AMENDMENTS TO THE DRAWINGS

REMARKS

Figure - 1

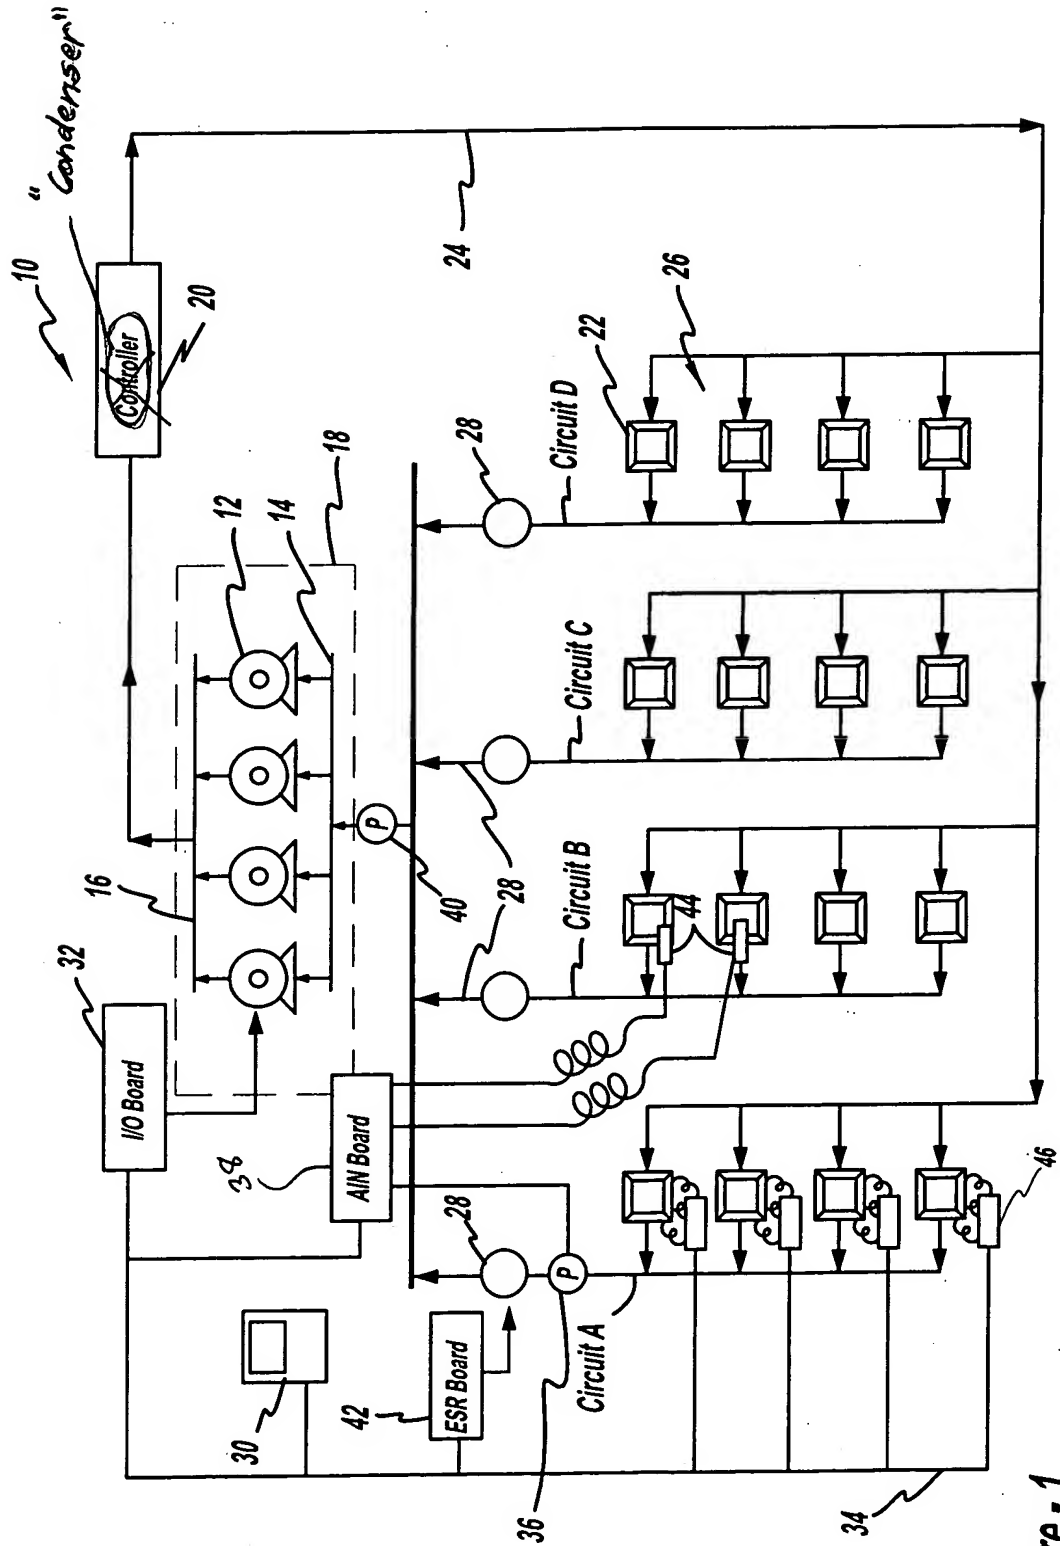
Applicants have attached revised drawings for the Examiner's approval. Applicants have amended FIGS. 1 and 3 to correct typographical errors. Specifically, Element 20 of FIG. 1 is now properly designated as a "condenser" rather than a "controller" and the control logic of FIG. 3 is now properly designated by reference numeral "60" rather than reference numeral "50." Favorable consideration of the revised drawings is respectfully requested.
